MEMORANDUM

TO: District of Columbia Zoning Commission

SUBJECT: Public Hearing Report for Zoning Commission #25-07, Design Review in the Northern Howard Road (NHR) Zone

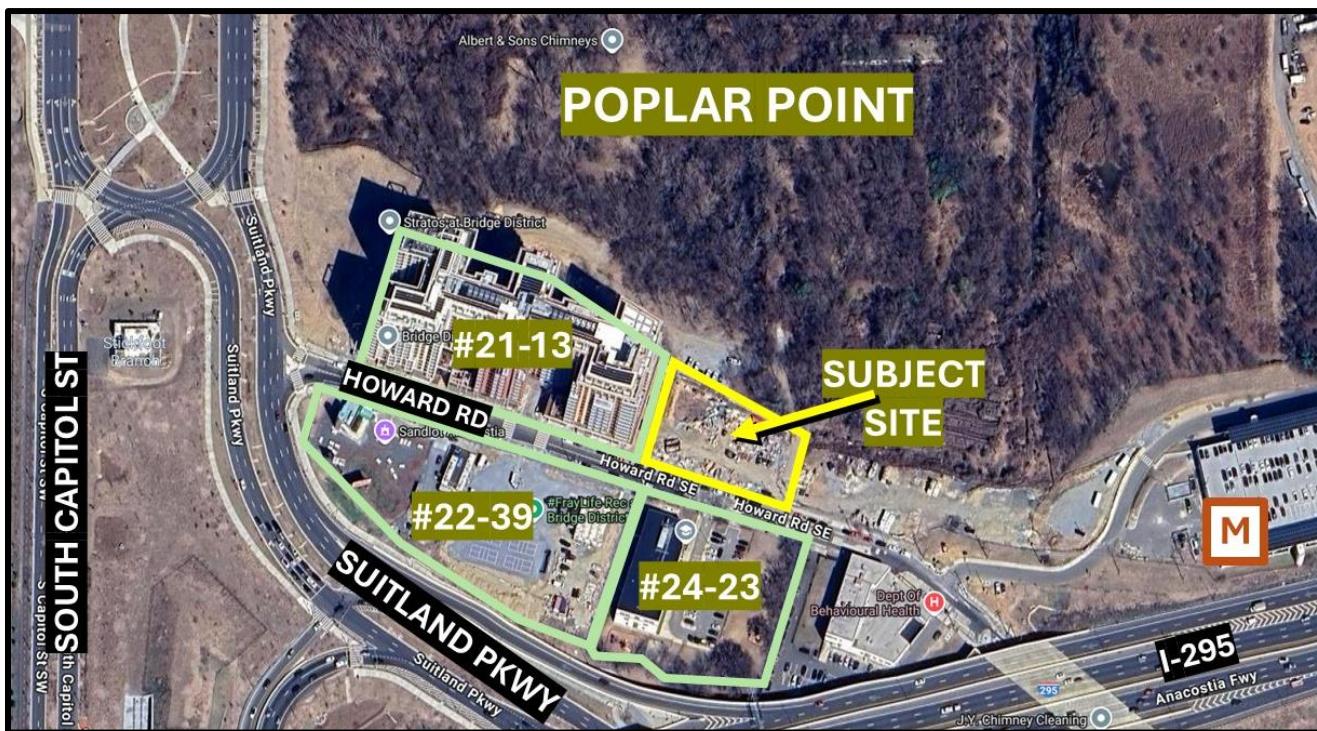
With regards to the request for special exception setback relief for guardrails on the roof of the building, the zoning regulations state in Subtitle C § 1506.2 that penthouse setback special exception relief is not permitted for buildings built to the maximum height allowed under the Height Act. At least one previous interpretation of the penthouse and rooftop structure provisions, however, determined that special exception setback relief where the Height Act would not require a setback is possible and relief was granted in that case. While OP questions whether that would apply in this case, OP has advised the applicant to obtain a determination from the Zoning Administrator that this special exception relief is permitted. If the Commission determines that the special exception relief under zoning is permitted, OP would not be opposed the granting of the relief for the proposed guardrails.

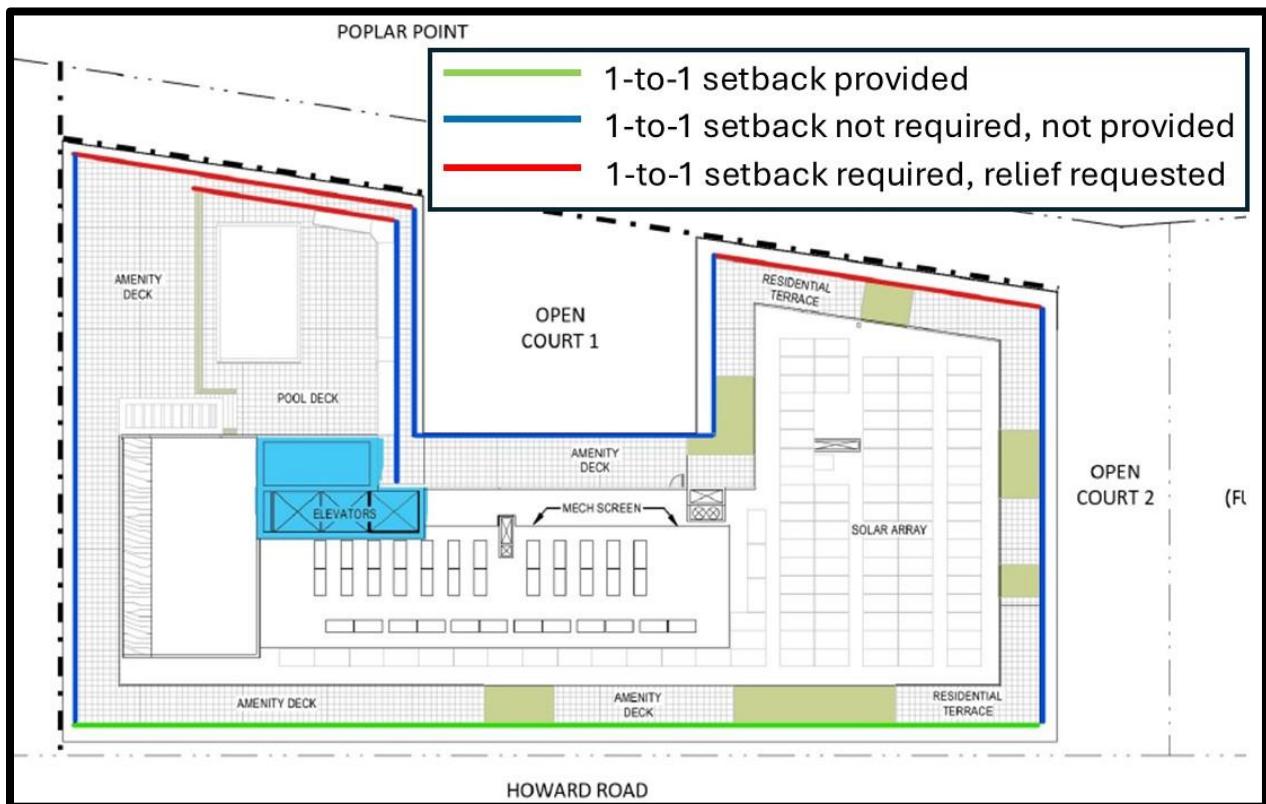
The applicant requests special exception relief from the uniform enclosing wall height requirement at the west end of the penthouse. Section C § 1503 requires a single, uniform height around penthouse habitable space. The applicant requests relief from this requirement at the west end of the penthouse to include a taller clearstory window into the amenity space. Please refer to the section drawing at Exhibit 11A, Sheet A4.03.

The applicant's written statement (Ex. 3, pp. 29-30) suggests that relief would result in a better design for the rooftop amenity spaces. The clearstory window would allow additional light into the amenity spaces, creating a more welcoming environment. Also, the elevator vestibule would facilitate access to the pool deck for mobility-challenged residents.
